RE: Slot Yard House

1220 Iron SW

Request for Certificate of Occupancy - Permanent

Grading and Drainage Plan

GRADING&_DRAINAGE_PLAN

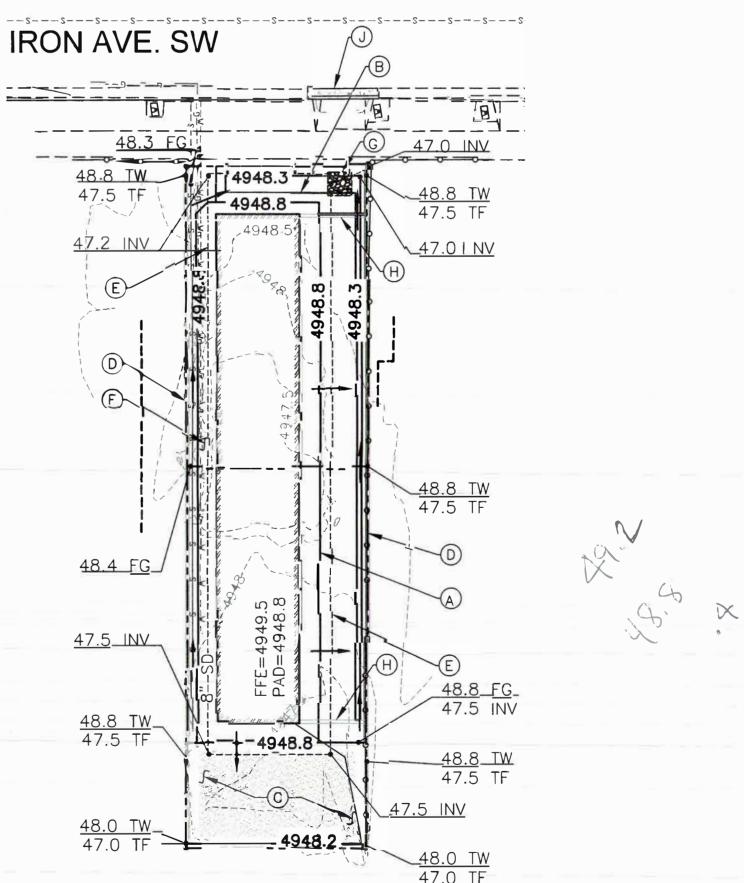
Based upon the information provided in your submittal received 5/29/2018, this plan is approved for Grading Permit and Building Permit. Please attach a copy of this approved plan and letter into the construction sets in the building permitting process prior to sign-off by Hydrology.

A Private Drainage Easement will be required on the plat with the City's standard maintenance note for the pond.

Prior to Certificate of Occupancy release, Engineer Certification per the DPM checklist of this plan will be required.
